Access Compliance Report

Public Rights-of-Way

| Intersection ID: 44470 | Main Street: COREY_COMMON_AV | Cross Street: NEWFIELD_ST | Location: W |
| ADA ID: DAB8032AB944 | Ramp Type: BlendTrans1 | Initial Pass/Fail: Fail | Overall Compliance: No |

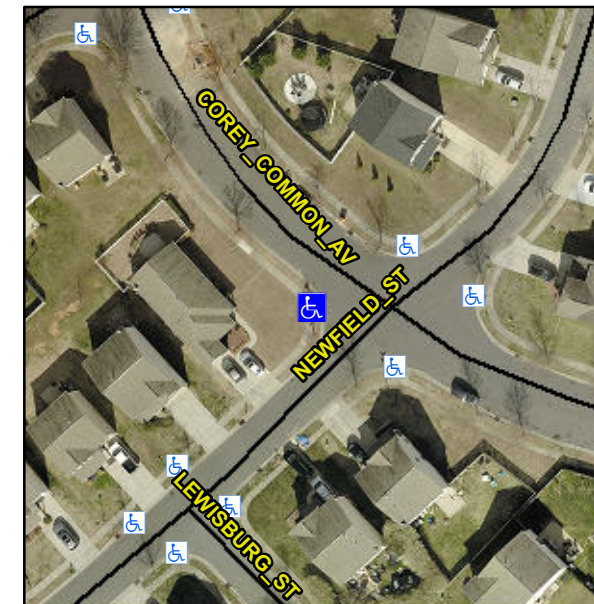
Not Found, R304.5.1

| Compliance | Description | Data | Compliance | Description | Data |
|------------|-----------------------|-------|------------|-----------------------------|-------|
| No | Ramp Width (in) | 47.5 | Yes | BlendTrans XSlope (%) | 0.6 |
| | | | No | Curb Slope (%) | 14.2 |

Remove & Replace Curb Ramp With Two New Directional Ramps or Equivalent.
